Docket Item # 3
BAR CASE # 2009-0291

BAR Meeting
January 6, 2009

ISSUE: Alterations
APPLICANT: Frederick Kroesen
LOCATION: 1250 S. Washington Street (Unit 705)
ZONE: RC/Residential

Figure 1: Diagram of proposed alterations.

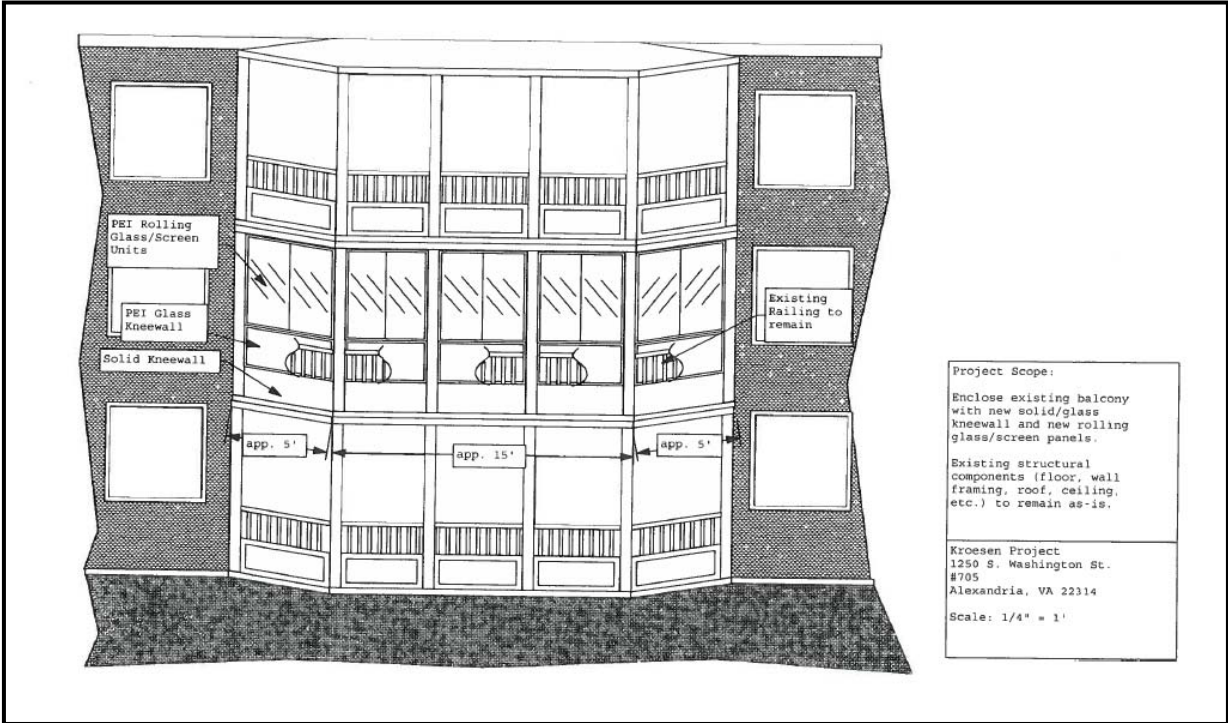
The applicant is requesting a Certificate of Appropriateness to enclose a balcony at unit 705 of the Porto Vecchio high rise residential condominium building at 1250 South Washington Street. The proposed construction comprises the installation of new solid glass kneewall and new solid glass and screen rolling panels into the existing structural components. The existing floor, wall framing, and ceiling are to remain as-is without alteration. The proposed framing material is extruded aluminum in an anodized Quaker bronze finish. The proposed glass will be tempered and laminated with a SB70VT Low-E coating.

Staff recommends approval of the application as submitted, due to the fact that the proposed balcony enclosure does not affect the structural integrity of the building and the alterations are in keeping with prior approvals of the Board at the same location.
